**FIN 2004-02**

**Fisher Information Notice: FIN 2004-02**

Fisher Pneumatic Instrument Relays with Nitrile Elastomer Diaphragms

Figure 1. Diaphragm Locating Tabs

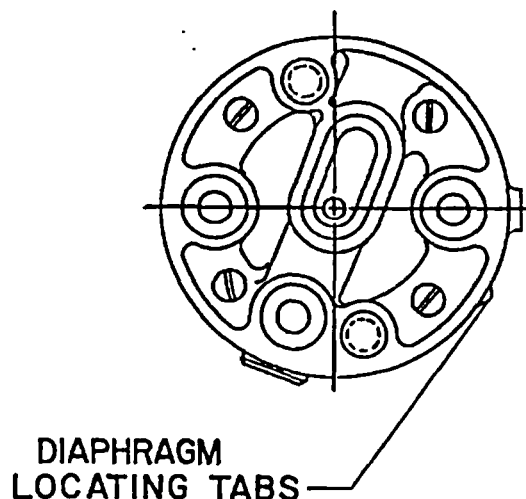
In February 1999, Fisher increased the thickness of the nitrile diaphragms in the Type 83 Series relays as part of a material consolidation program

Recently, Fisher was notified that the installed performance of several Type 3582 Positioners did not appear to be acceptable because of reported "sluggish" relay behavior. The most notable characteristic of this behavior is an increase in time required to exhaust the actuator diaphragm case (stroke time).

One can determine which type of nitrile diaphragm is present in a given relay by looking at the alignment tabs (See Figure 1) on the diaphragms that extend outside the relay segments:

- The thicker diaphragms are identified by red dots, or red (or pink) wavy lines, or light blue wavy lines.
- The thinner diaphragms are identified by white dots or white wavy lines. This is the same marking used for the pre-1999 diaphragms.

To correct this problem, Fisher has reduced the thickness of the nitrile diaphragm to its previous, thinner dimensions. Table 1 provides a conversion list for replacement part numbers.
